C5.6 Concrete Slab

C5.6.2 CCS LRFD

Methods Memo No. 186: Revision Open Rail Details to J24-06, J30-06, J40-06, J44-06
5 November 2007 (These corrections have been made.)

6j1 bar – Bent Bar Detail

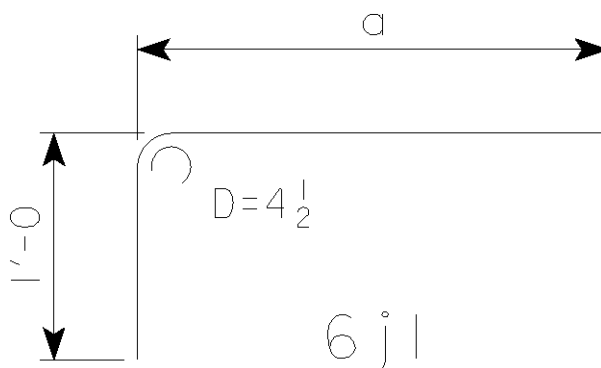
An error has been found in the open rail details on the J24-06, J30-06, J40-06, and J44-06 continuous concrete slab standards. The 6j1 bar should have been shown as a variable bar as shown in the table below. When using the open rail details on the standards the following correction should be made to the length of the 6j1 bar and rebar weight.

Bridge Length	"a" dimension	Total length	Total number	Revised bar weight
70	3'-6	4'-6	152	1027
80	3'-7	4'-7	184	1267
90	3'-8	4'-8	200	1402
100	3'-9	4'-9	216	1541
110	3'-10	4'-10	232	1684
120	3'-11	4'-11	264	1950
130	4'-1	5'-1	280	2138
140	4'-2	5'-2	296	2297
150	4'-3	5'-3	312	2460

Revisions will be made to the standards and released as soon as completed. If you have any questions please check with Dean Bierwagen or Thayne Sorenson.
